Sent: 1/06/2021 6:55:47 PM
Subject: Formal Complaint - re: DA/2021/0383 Development Application 53B Amourin Street, North Manly
Attachments: Letter_-_Response_to_Submission_from_Corona_Projects.pdf;

**Response to the rejections outlined on 5/05/21 from Corona
Projects re DA/2021/0383 Development Application 53B
Amourin Street, North Manly**

“Alterations and additions to a dwelling house including garage.”

Figure 3 – Principal private open space of 51 Amourin Street (Corona Projects, 2021)

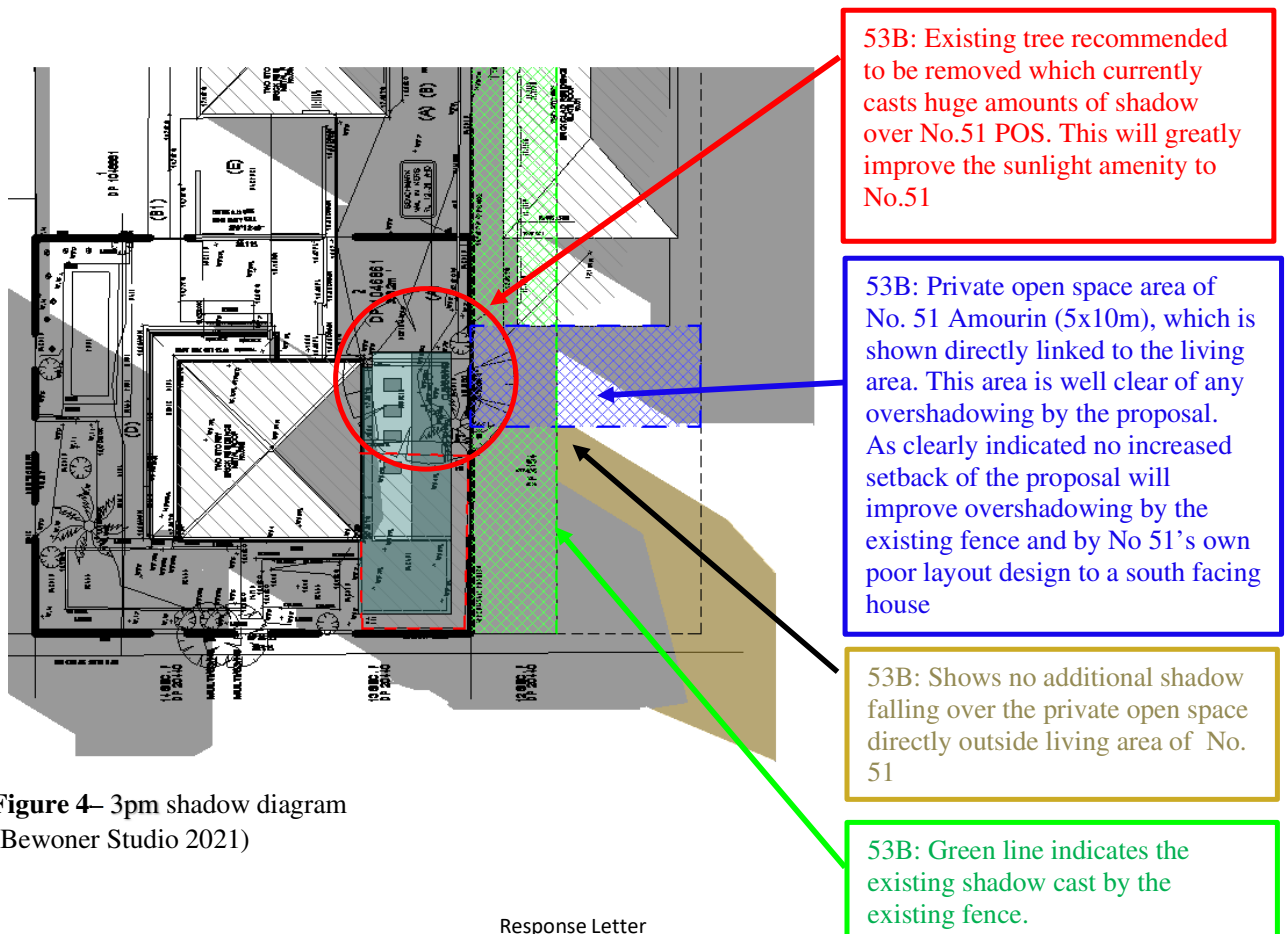
53B Response: The owners of No.51 should have considered this when purchasing the property as all of the shadow cast in the calculated private open space is cast from the existing paling fence and their own house.

The DA Proposal for 53B Amourin has been carefully designed in order to minimize the over shadowing of the proposal on 51 Amourin street. Requirement 2 of the DCP2011 D6 access to sunlight requires that at least 50 percent of the private open space of each dwelling requires a minimum of 3 hours of sunlight between 9am and 3pm on June 2. This requirement has been fully met and carefully considered in the design of the proposal as follows:

- a. The private open space of 51 Amourin street is a 5m x 10m area directly outside the living space of 51. The calculated private open space is well clear of any additional overshadowing that will occur on the POS of 51 at 3pm.

Figure 5 – Proposed visual bulk impact (Corona Projects, 2021) This is a false indication of the proposal.

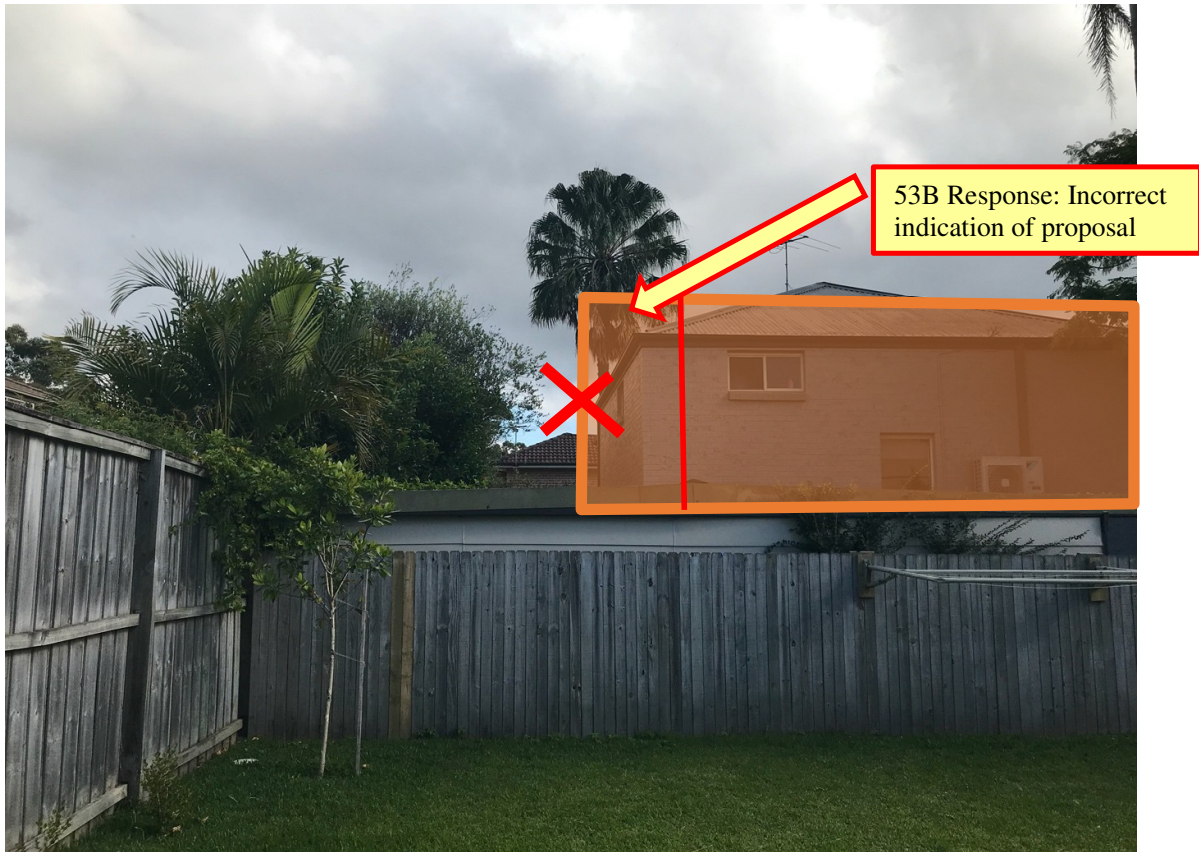
53B Response: This is incorrect, the proposal includes new screening shrubs between No. 53b and No. 51, with an increase in the setback area allowing for screening to be planted along the eastern boundary of 53b.

Figure 7 – Proposed visual bulk impact (Corona Projects, 2021)

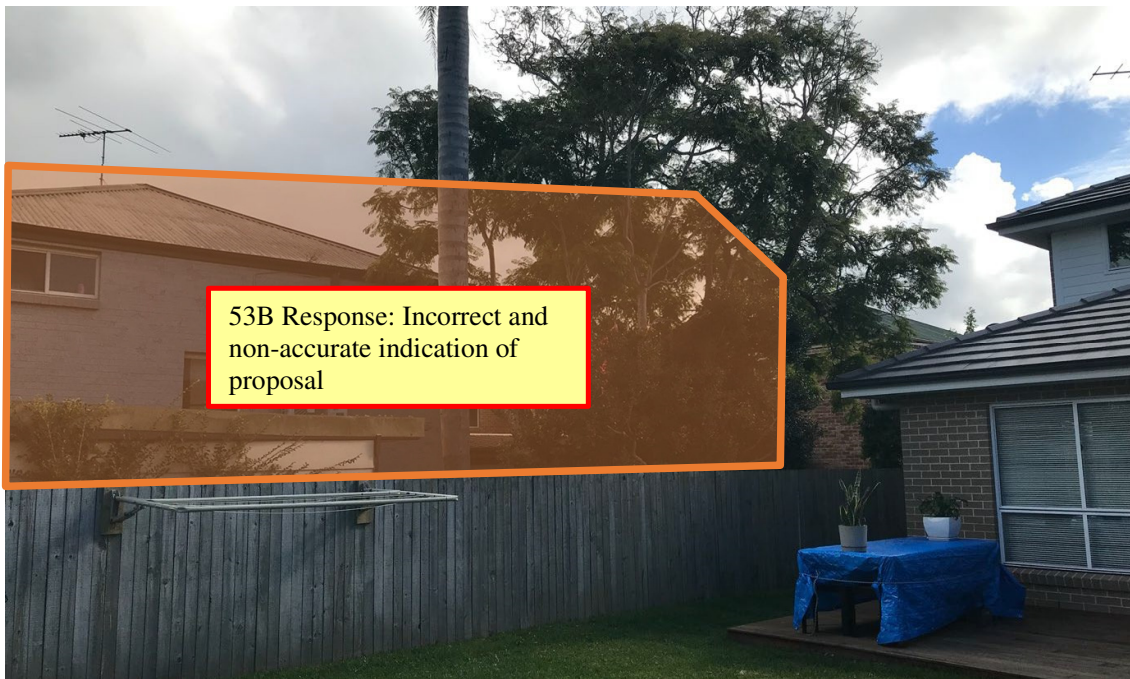
53B Response: This image is not a true depiction of the spatial area the proposed development will claim. It has been embellished for dramatic effect. The arborist report suggests trees will be included between the new development and fence line which should alleviate any concern about visual bulk and a sense of enclosure, this will ensure considerably more foliage than currently exists between the properties as the existing car port is not 0.9M off the side boundary and doesn't allow for any foliage to reside.
